PREVOST

SAFETY RECALL

SR23-13

DATE :	May 2023	SECTION :	06 ELECTRICAL
SUBJECT:	Power Cable Unsuitable Grommet

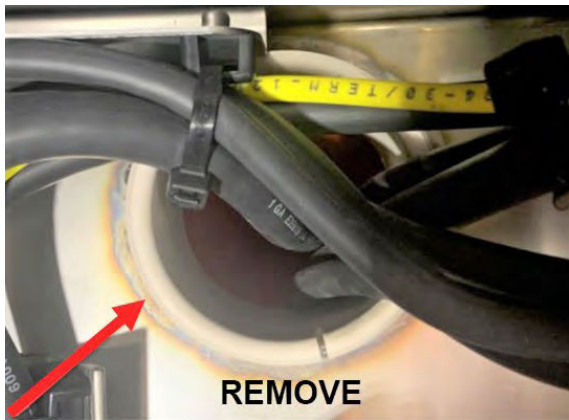
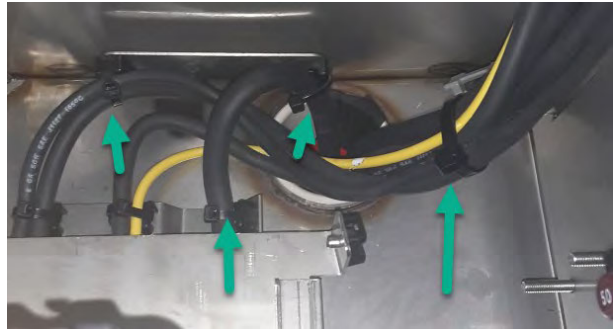
On vehicles affected by this recall, electrical power distribution cables routed through a metallic panel are not protected by a suitable grommet (grommet was cut in half and both parts were glued to the panel). If one of the halves fell off, the wiring conductor insulation could become damaged by chafing on the edges of the panel, potentially causing a short-circuit.

1. Locate the grommet location in the rear electrical compartment.

- Open the vehicle curb side engine door.
- Open the rear electrical compartment (next to the batteries).
- In the compartment, the two part grommet is installed in the cable pass through hole located at the top right corner of the compartment (hidden behind the battery equalizer).

2. Cut all the cable ties holding the power cables passing through the hole.
3. Remove both halves of the grommet.
 - Discard the grommet halves.
 - Remove residual adhesive on the panel as required.

4. Cut the supplied **069464** cable protector (grommet).
 - Slice the grommet with a slant cut to allow the insertion of the cables.
